#### **DESIGN REVIEW COMMISSION STAFF REPORT**

SUBJECT: Wood Hollow Hotel

Design Review Workshop #2 File: P2015-091; Design Review

APN 125-202-13 and -14; 7701 Redwood Blvd.

# EAST ELEVATION - COMPARISON

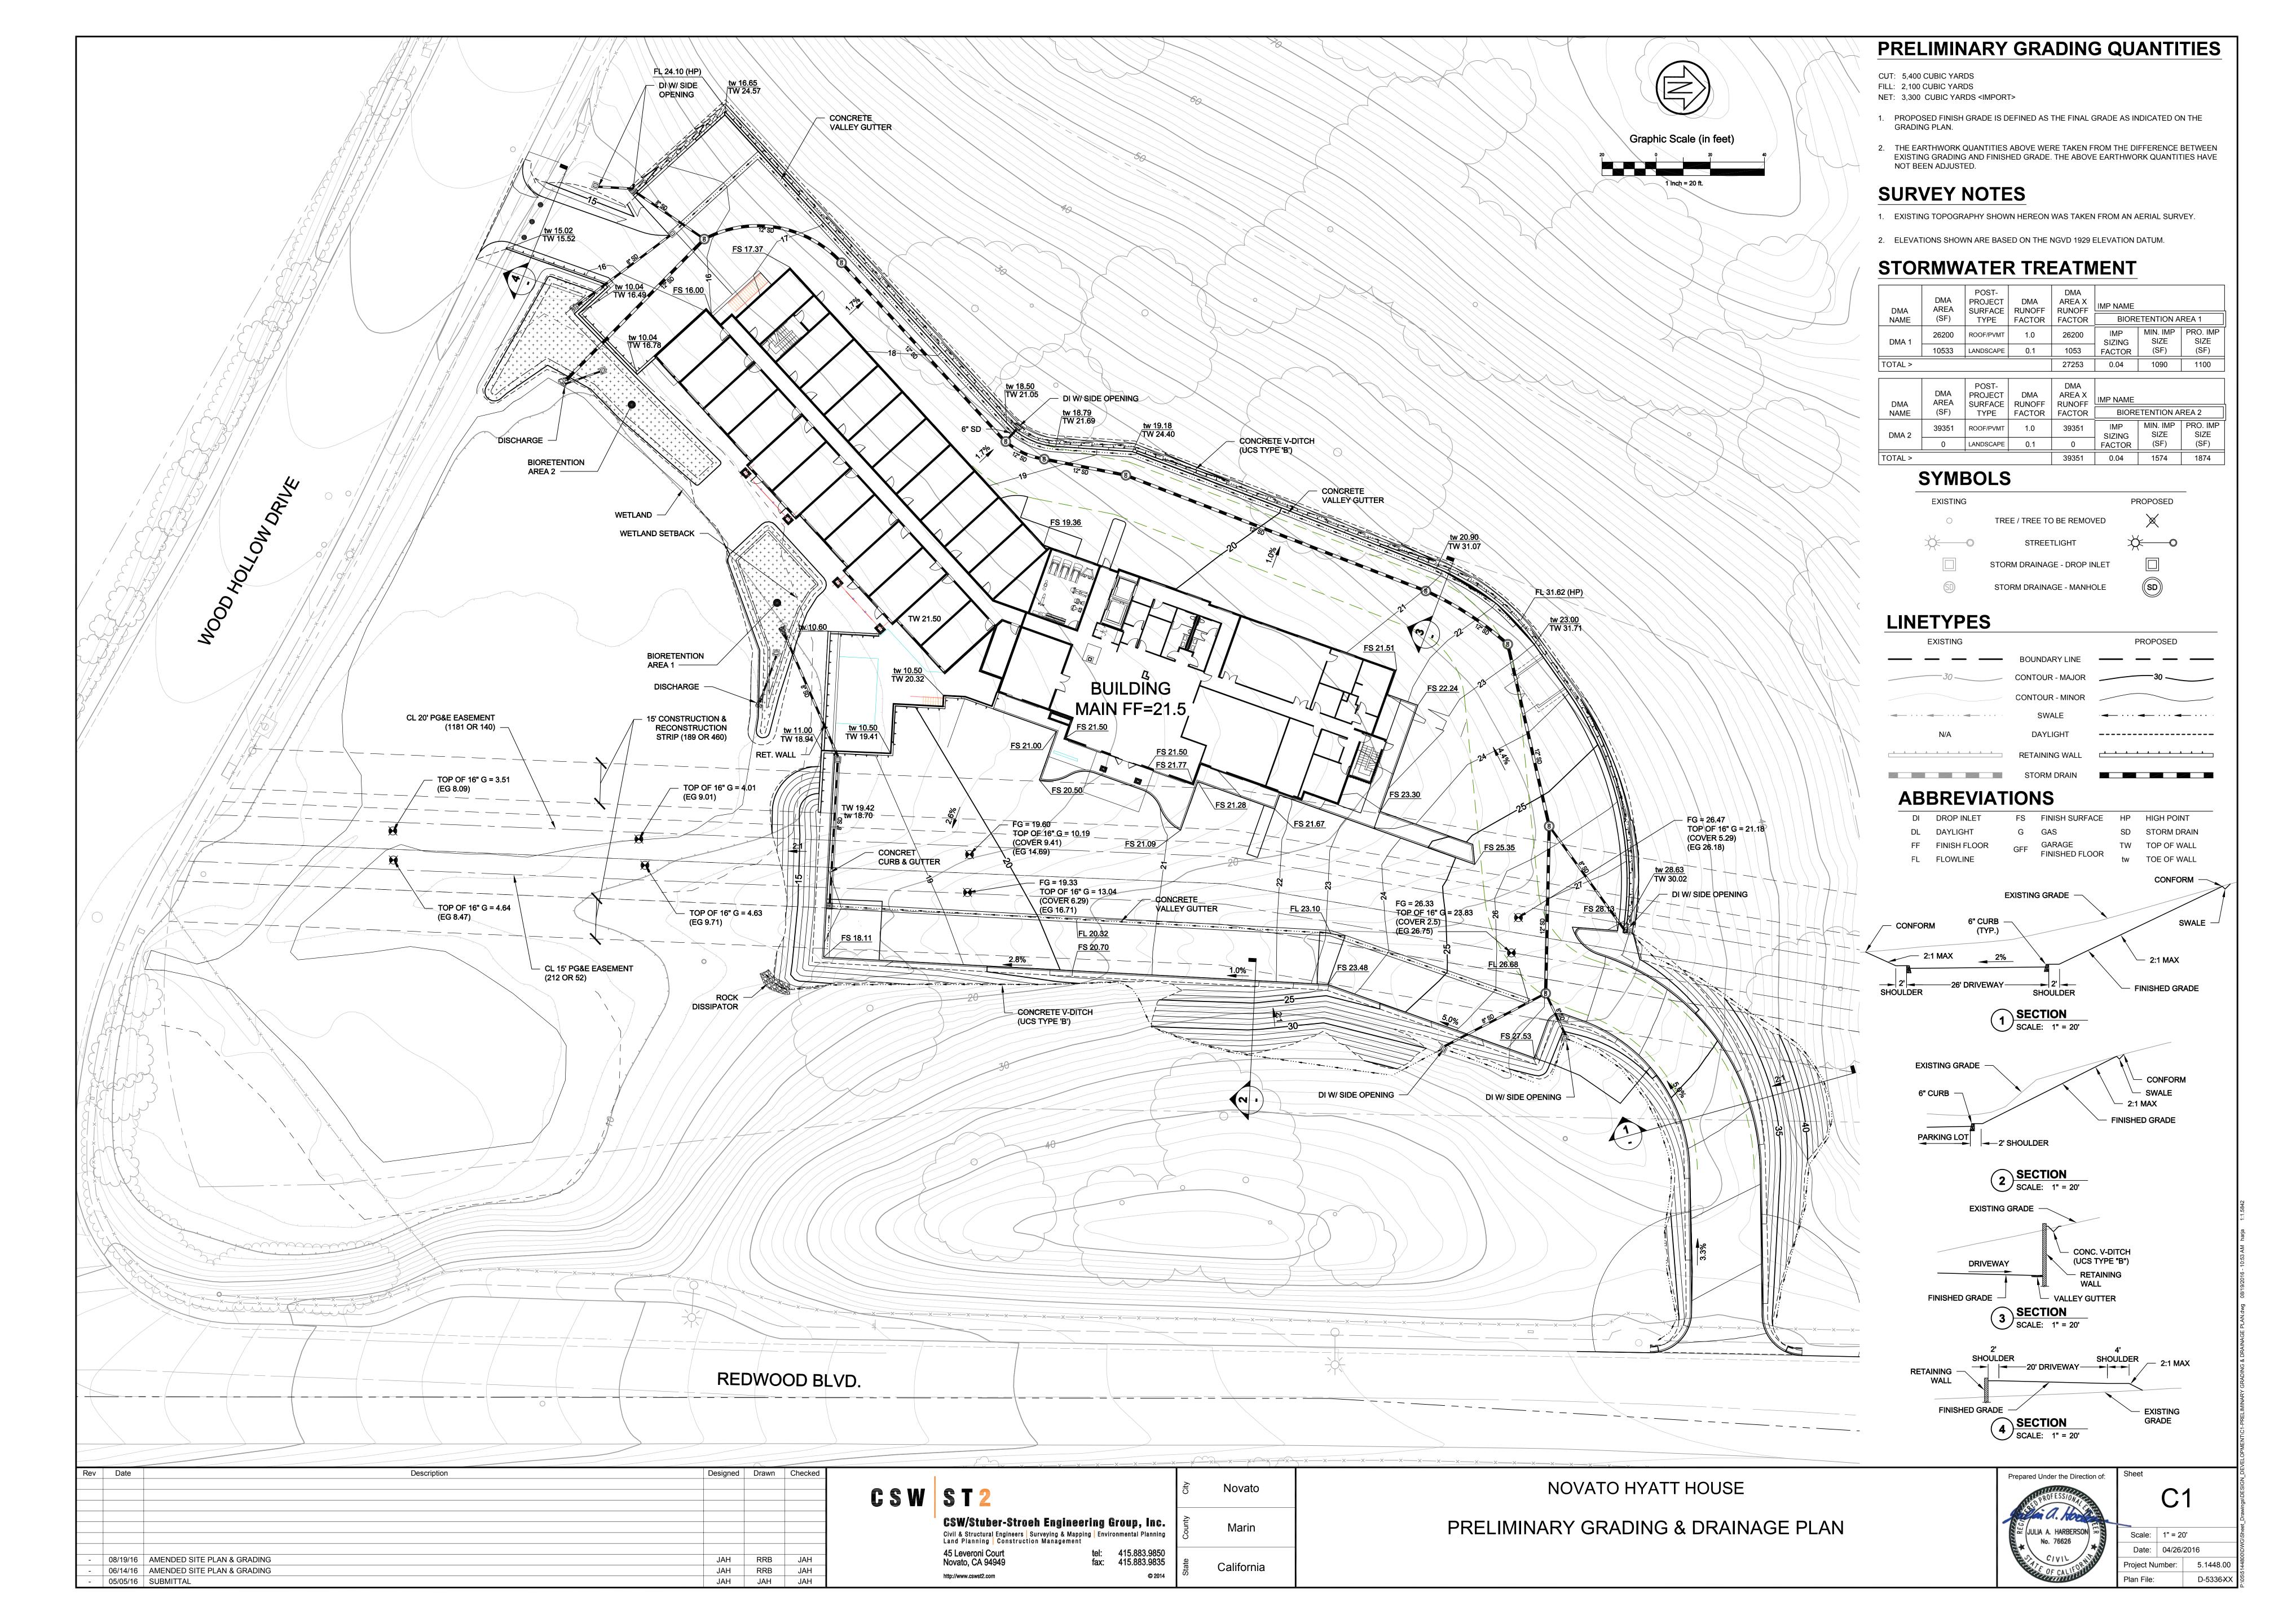
- ➤ Revised overall architectural style of building to include muted, natural colors and materials.
- Replacement of flat roof design for sloped roof pitches with gabled ends.
- Reduction of overall height of the building from 48 feet 6 inches at the highest point to 41 feet 11 inches at the highest point. Entire hotel dropped by one story.
